**Attachment 1\_Answers to additional comments and requests submitted in the corresponding letter of The Ministry of Environment, Water and Forests of Romania Reg. No DGEICPSC/37558/12.11.2024. issued on November 12th, 2024 (hereinafter: Letter).**

Figure 9.2 Conceptual model of the proposed zoning system for monitoring the subject area.”

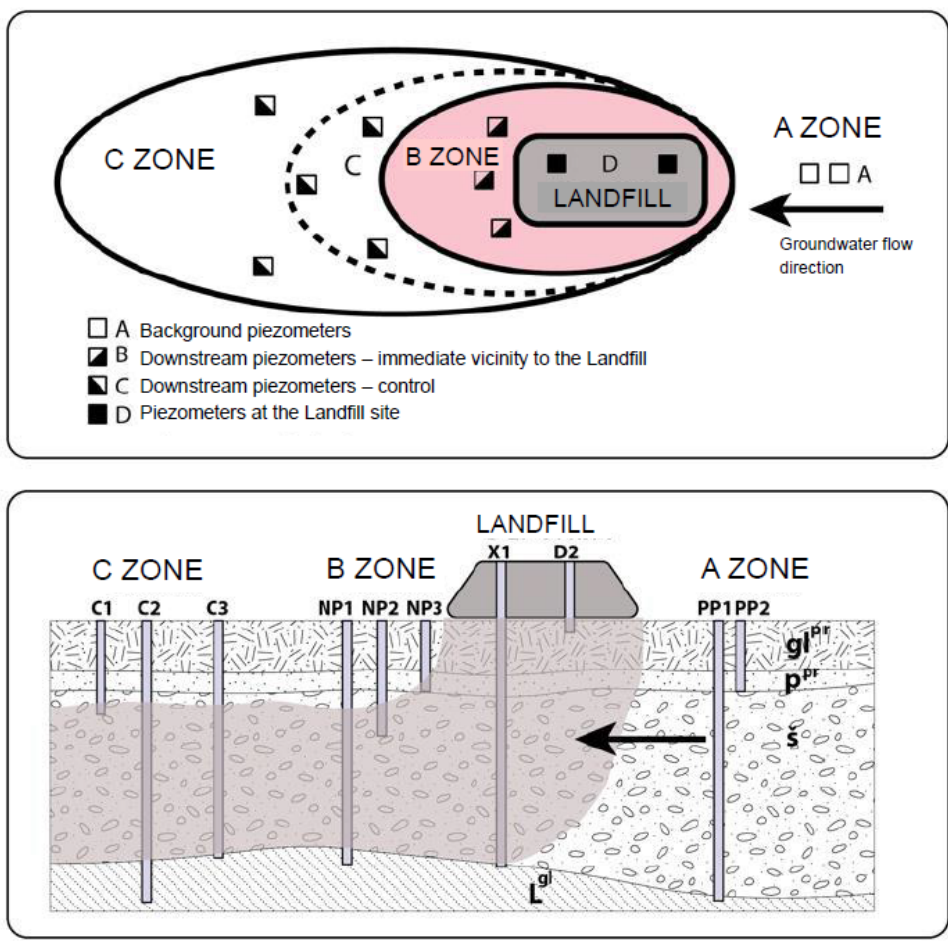
**Page 3 paragraph 11 (further referred as comment 6): The groundwater monitoring is carried out according to the presentation made in the material, through a small number of wells. We believe that in order to have an overview of the pollution of the underground water body (data necessary for the evaluation of the level of diffuse water pollution) and to estimate the influence of the quality of the groundwater bodies on the quality of the water body designated on the Danube River, it is necessary to extend the monitoring through at least 3 boreholes (2 on the banks of Danube River and one downstream of the investment).**

Answer: Indeed, the comment is well received, moreover it is in line with the strategy presented in the EIA report. The authors point out that on the site of chemical complex the number of piezometers (used terminology considered equivalent to boreholes) is significant, thus we can already indicate locations for the operating piezometers:

X5 (Coordinates N 44°17'3,68", E 22°38'8,2") & X3 (Coordinates N 44°17'11,68", E 22°38'50,0") are particularly design to monitor potential underground water contamination with respect to potential contamination of Danube River, both downstream of the investment. X2 (Coordinates N 44°17'1,97", E 22°37'13,05") on the other hand will be used as direct control on the project location. Moreover, the authors points out that it is foreseen that additional piezometers will be placed for the particular purpose. Please be referred to subsection 9.2.2.5 of the EIA report and particular to page number 622, where a proposal for additional monitoring of soil and groundwater in the area of the Eco Energy complex is

disclosed. In the reference section it has been stated: “The concept of establishing monitoring in order to alert early by establishing three zones of representative piezometers:

The concept is later adopted in 9.3. as a measurement requirement. Thereby, the authors believes that the addressed issue is in full alignment with correctly recognized need by the comment issued by Romanian authorities.

Figure 5.9 Wastewater and surface water sampling locations”.

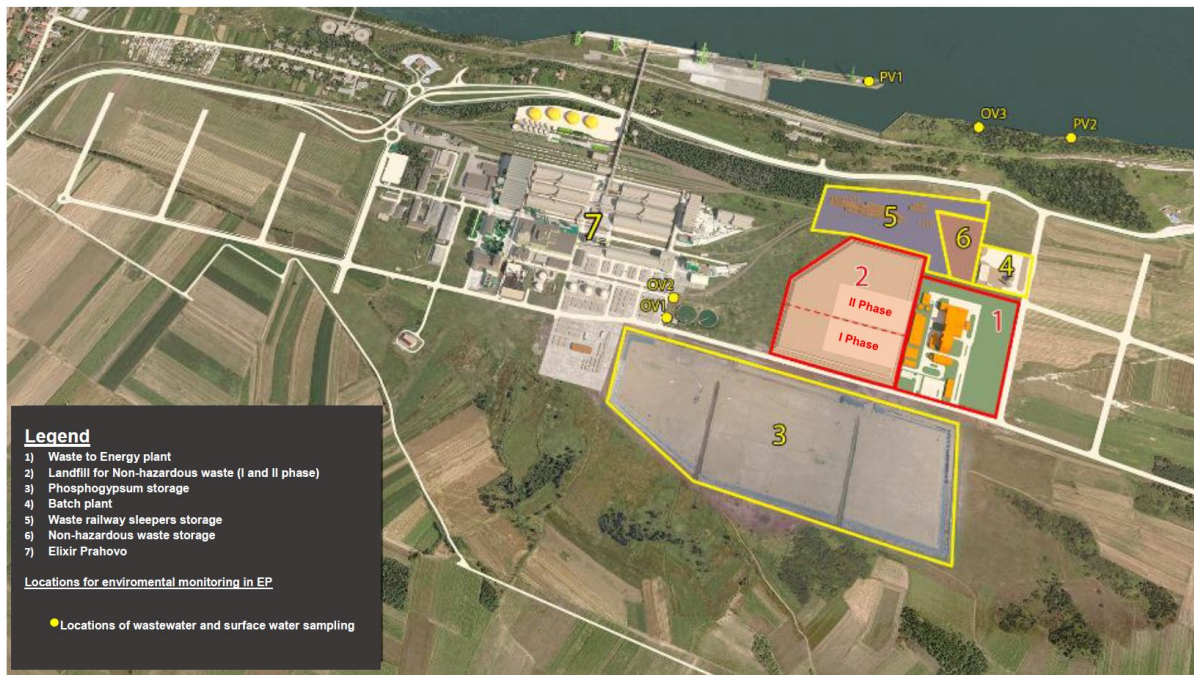
**Page 4 paragraph 2 (further referred as comment 8): The information on surface waters should also include aspects on water body status/potential and possible impacts.**

Answer: Water body status including the potential impact has been assessed in multiple aspects. On the one hand, surface water quality has been presented in zero condition analysis as a part of subsection 5 of the EIA report. More precisely, in page 371 it has been stated:

In 2024, in order to determine the zero state of wastewater quality and surface water quality of the Danube River for the needs of construction of the Eco Energy complex, the Institute for Prevention, Occupational Safety, Fire Protection and Development LLC Novi Sad, Branch "27. January" Niš carried out sampling and physico-chemical testing of the quality of waste and surface water at four measuring points, as shown in Table 5.7 and Figure 5.9 (Report on physical/chemical analyses is given in the Annex of Study).

Figure. process wastewater treatment schematic representation. “

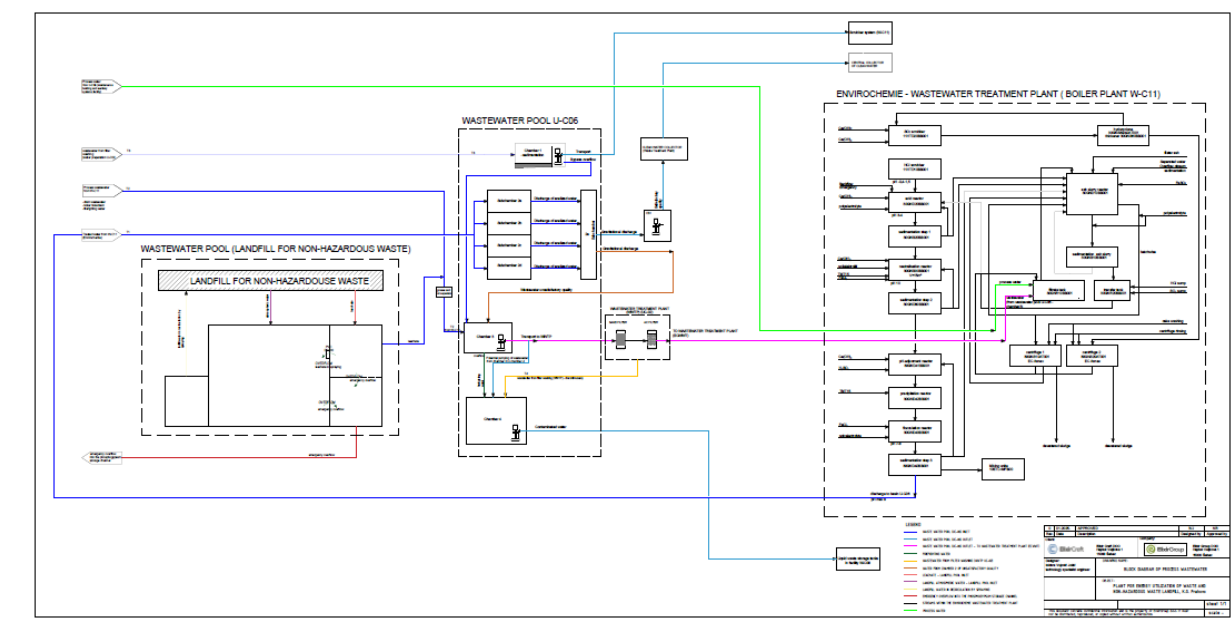
**Page 4 paragraph 3 (further referred as comment 9): Information on the complete leachate circuit from the landfill of non-hazardous waste (collection, storage, treatment, etc.) that could potentially have an impact on groundwater is presented disparately. A schematic representation of the entire flow should be included for easier analysis and monitoring of the flow of pollutants.**

Answer: A schematic representation will be provided in the amended EIA report within subchapter 3.5.5 where it will be outlined:

“the overall schematic representation of the entire process wastewater treatment schematic representation including landfill leachate treatment is provided on the Figure.

The leachate is collected with a drainage pipe system above the impermeable HDPE foil, before being subsequently directed to the wastewater treatment facility as one of the water streams for purification. The flowing is disclosed in 8.3.3 “
